SUBJECT: PLANS AND PROPOSAL ADDENDUMS

PROJECT: BR 2023(404)

CONTROL: 0035-04-039

PROPOSAL ADDENDUMS

TRAFFIC RAIL

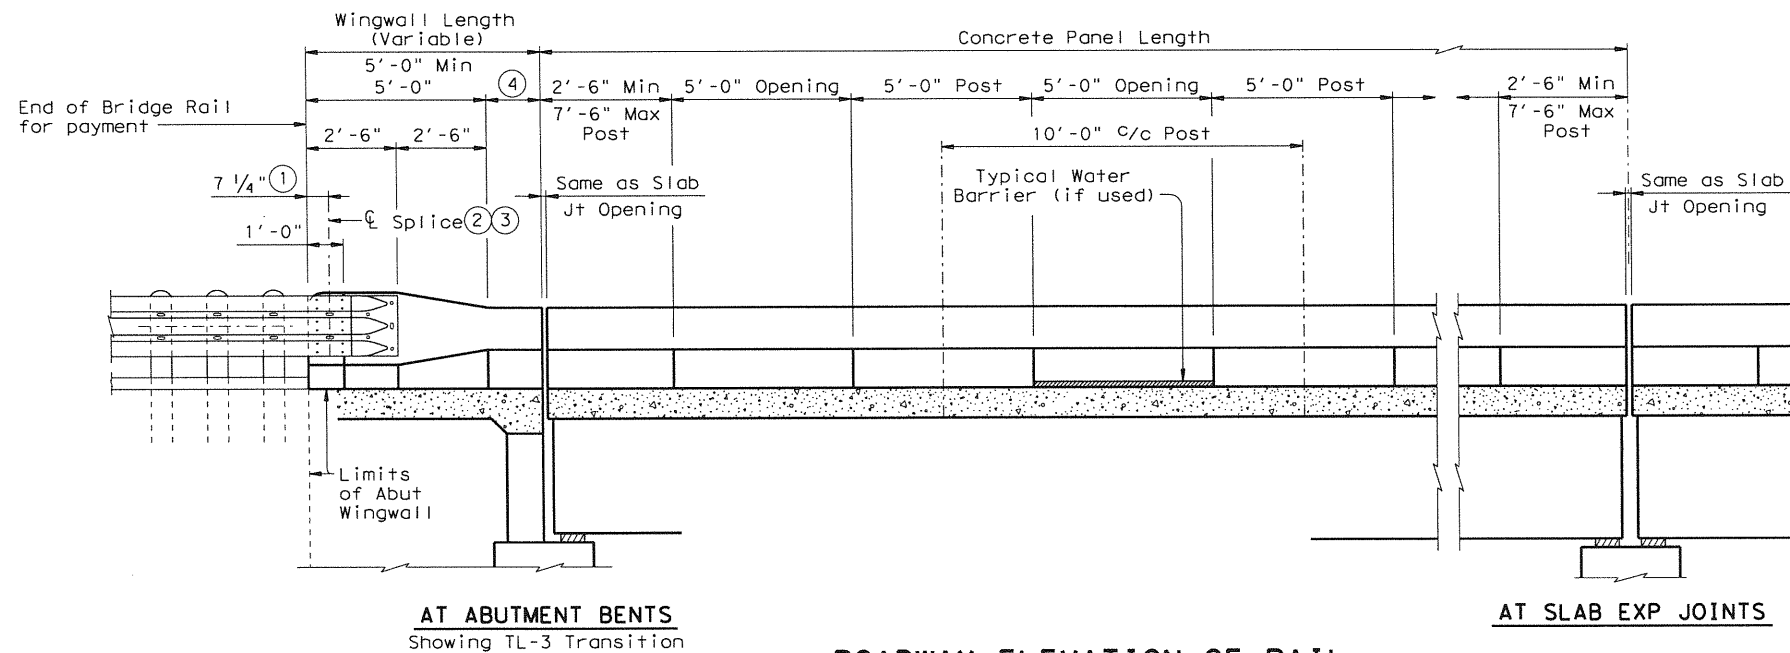
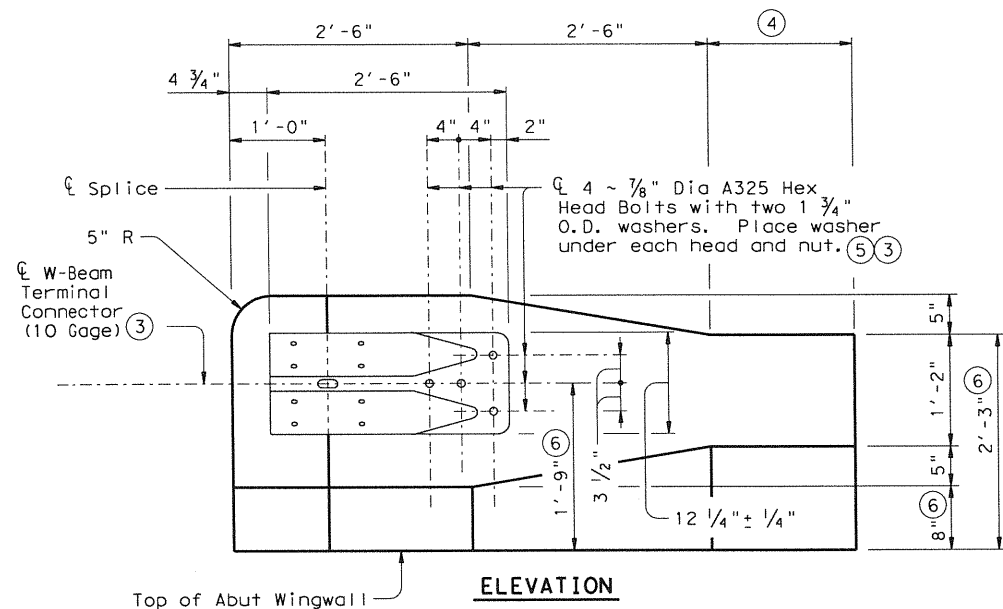
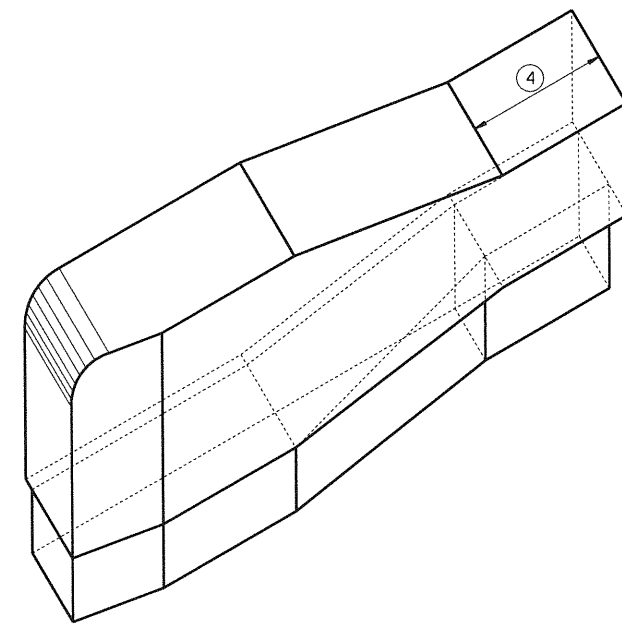
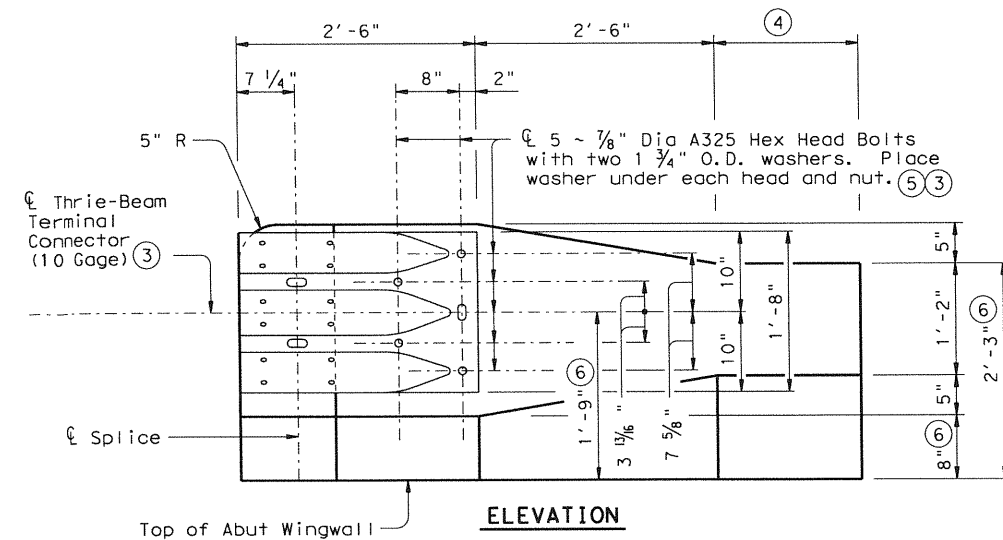
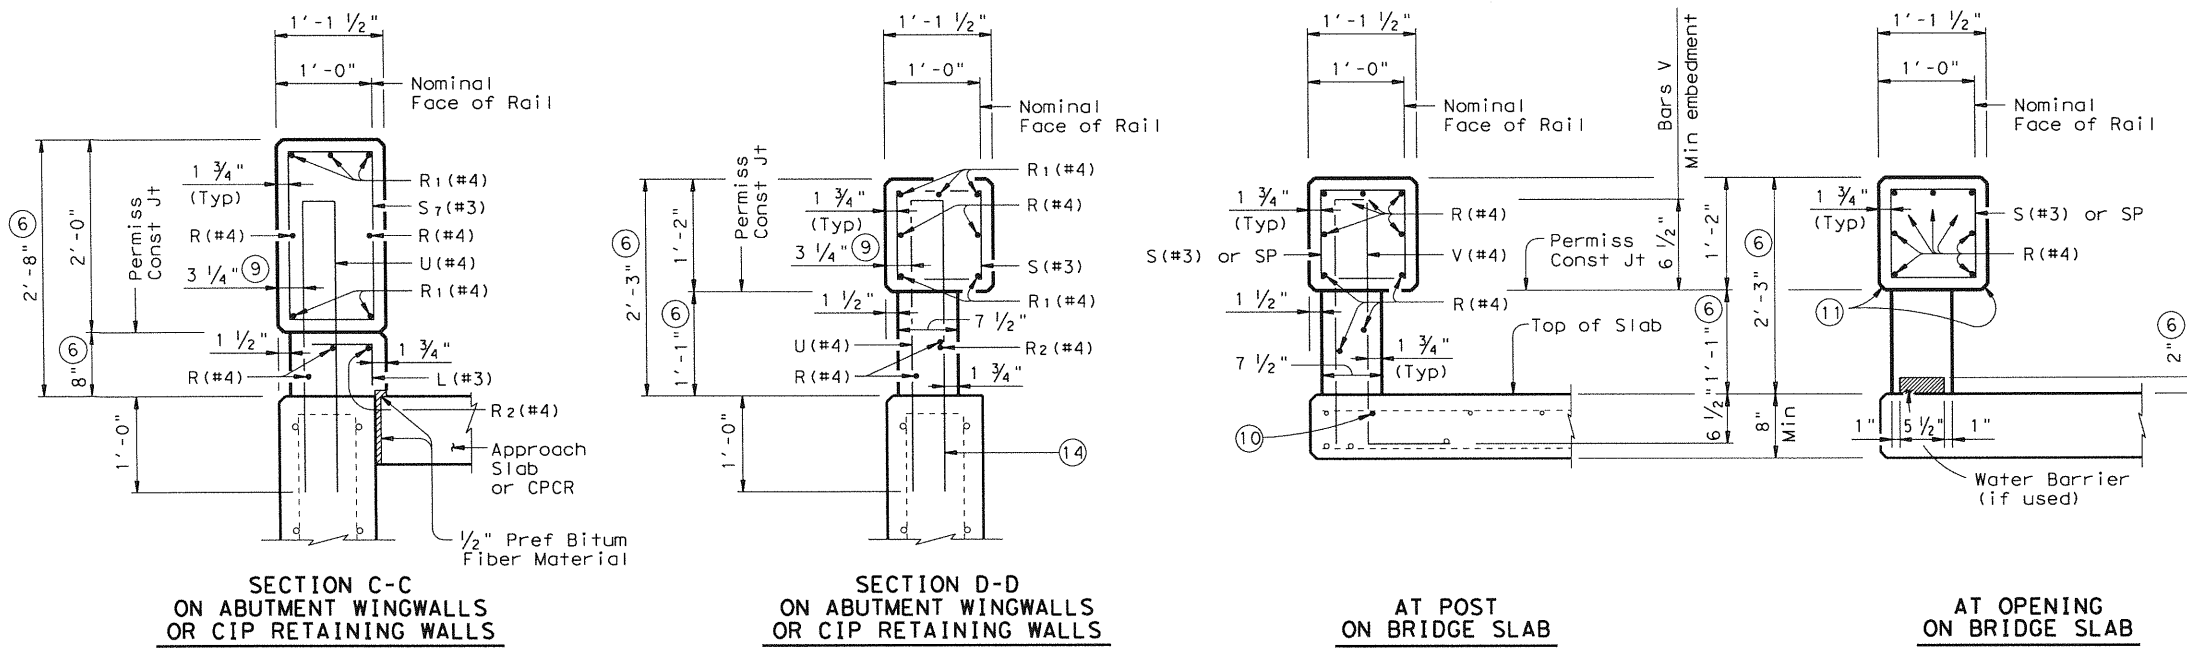
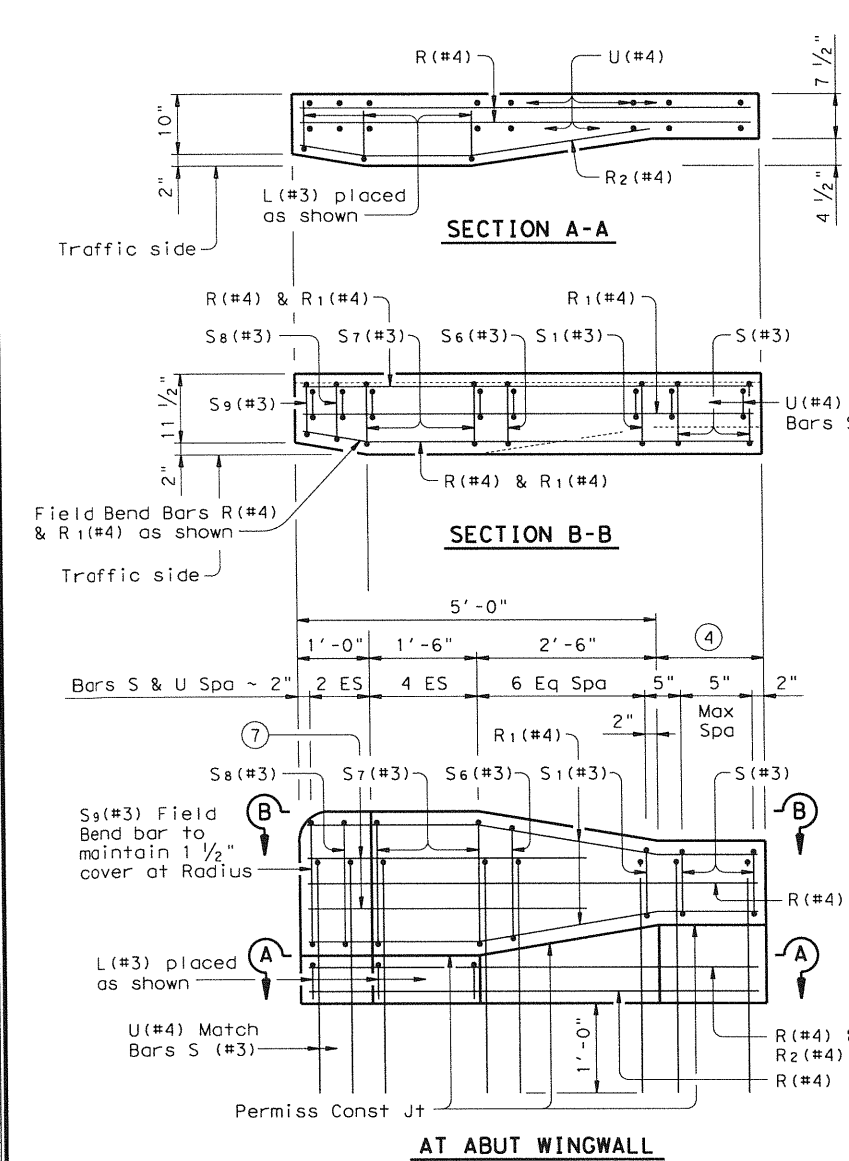
SHEET 36-37: RAIL RETROFIT SHEETS REMOVED AND REPLACED WITH T203
